VARIANCE REQUEST

Iowa Department of Natural Resources

To design a suction lift station, Our standards specified that under no condition shall the total dynamic suction lift and required net positive suction head exceed 22 feet, The engineer is requesting us to approve a 27 foot lift pump station.

RE: Bussey, Iowa Sewer Improvements
MEC 87010

LOCATION: BUSSEY, I.A.
W.W.T.P.

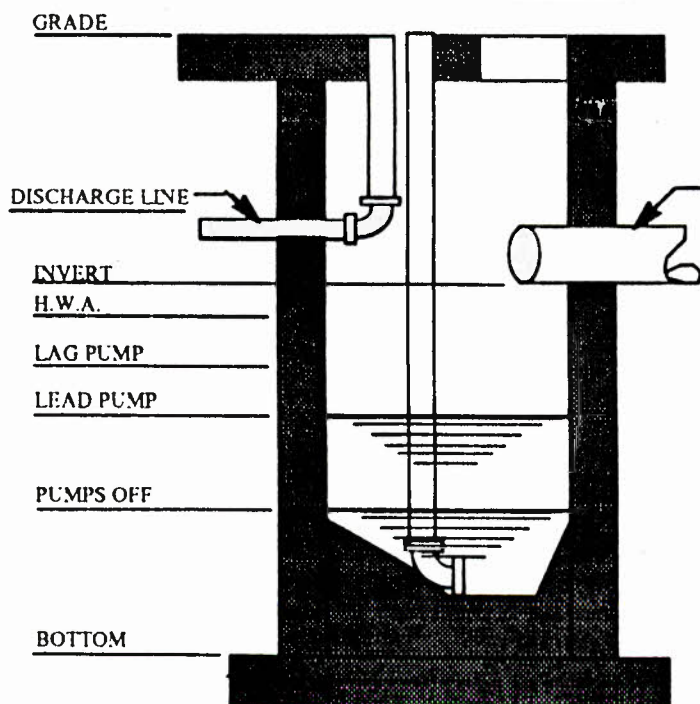
Verne Gongol, D. J. Gongol Assoc., asked me to do the TESL calculations for the 6' x 6' packaged station for the subject project.

This station will have duplex T4A3-B pumps and, as I understand, the design condition is 230 gpm at 72.7' tdh.

From the information provided I have calculated excess NPSH will be a positive 2.83'. The station should work satisfactorily at these given numbers for center line and suction, as indicated on my work-up sheet.
